STS-102 FLIGHT READINESS REVIEW

February 27, 2001

Orbiter

Water Spray Boiler Assembly & Controllers

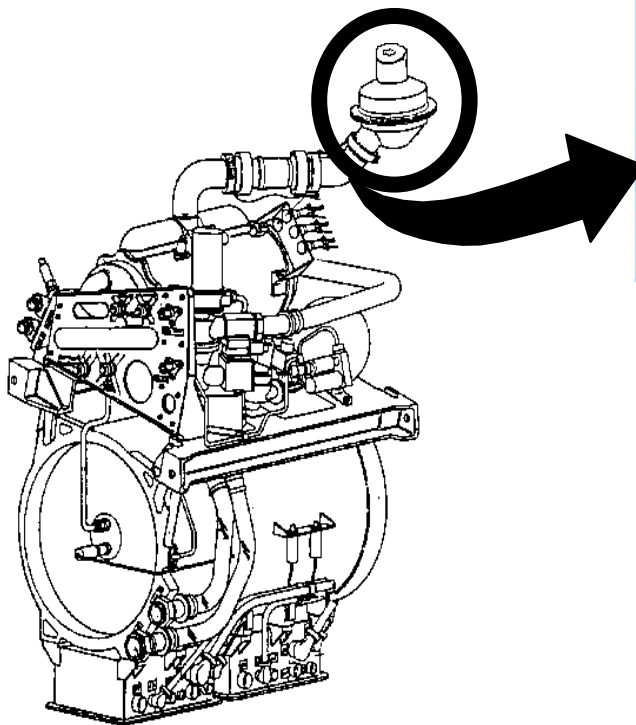
- Water spray boiler (WSB) 2B steam vent nozzle heater dropped off-scale low (<122 °F) during STS-92 pre-entry
- WSB 3B steam vent nozzle heater failed to operate during STS-92 pre-deorbit

- Vent nozzle heater failure can cause the loss of WSB due to orifice icing/blockage

- Review of STS-92 flight data shows that both vent nozzle anomalies are due to vent nozzle heater failures
- Six previous flights experienced similar anomalies which were attributed to erratic cycling/heater braze joint failure
 - STS-61C, -41, -39, -43, -53 & -86
- In the existing design, heaters are not hermetically sealed, making the heater coil susceptible to corrosion/oxidation cracks at the braze joints
 - A design mod is in the process of being implemented to manufacture and procure hermetically sealed coil heaters (-004 configuration)
 - Both failed heater assemblies have been replaced
 - System #3 has the new hermetically sealed (-004) units

- Two of the three OV-103 vent nozzle heater assemblies have been replaced
 - System #3 has the new hermetically sealed units
- Each of OV-103's WSB systems passed OMRSD checkout during the STS-102 processing flow
 - Vent nozzle heater performance will again be verified when heaters are turned on prior to launch
- Each vent nozzle assembly has a fully redundant heater system

Organization/Date:
Orbiter/02-27-01**FLASH EVAPORATOR ASSEMBLY SCHEMATIC**

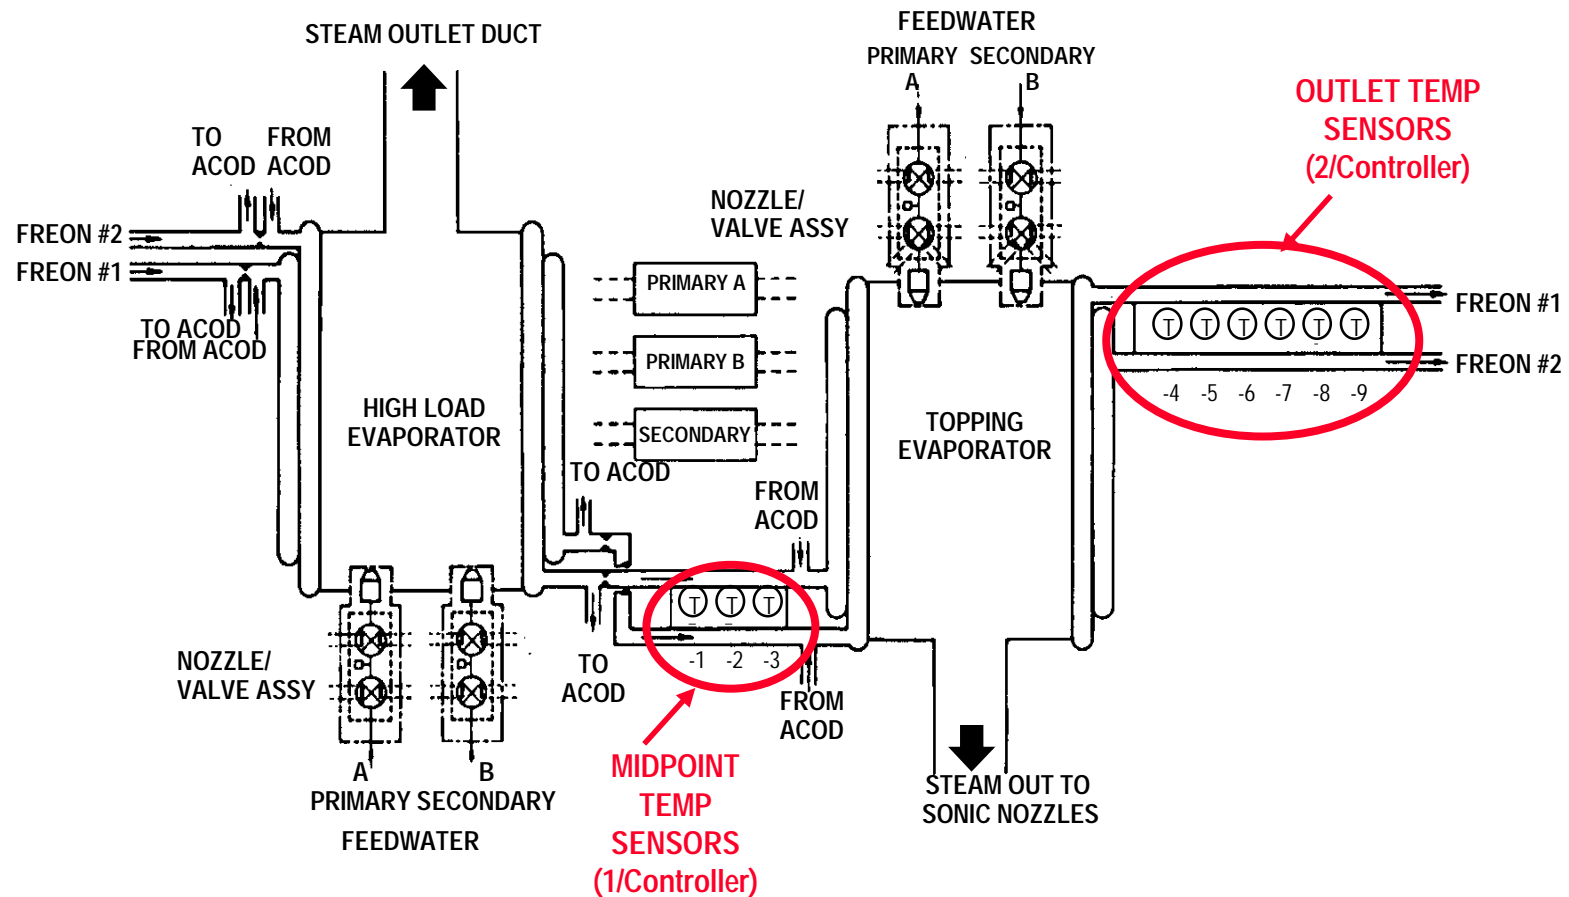
- FES shutdown in overtemp-rate-shutdown mode twice when operated in Prim B Full-Up mode during STS-92 de-orbit prep checkout activity

- Loss of redundant cooling in Prim B Full-Up mode

- Prim B Full-Up mode typically used for entry if Prim A Full-Up used for ascent, and vice versa
- During STS-92 de-orbit prep FES checkout activity, the FES shut down when operated in Prim B Full-Up
 - Following a core flush, Prim B was reactivated, but again shut down
- In total, all 7 modes of operation were run at some point during the mission, providing some data for evaluation of controllers, cores, water spray valves, and sensors
- Flight data led to initial belief that Midpoint sensor B was cause of the problem
 - Freon temperature oscillation looked similar to one produced by a degraded midpoint sensor block that has an air gap between the sensor and the block's thermal mass
 - FES midpoint sensor problems have caused shutdowns in the past

- Cause of STS-92 is most likely due to a combination of FES aging & activation at low temp
 - Problem can be prevented by instructing crew to activate FES at higher temp – Option being evaluated by MOD
- Observed core degradation is not expected to significantly impact FES performance prior to OMM
- System redundancy and in-flight procedures are available to handle cooling mode loss
 - Seven modes of operation available to provide FES cooling
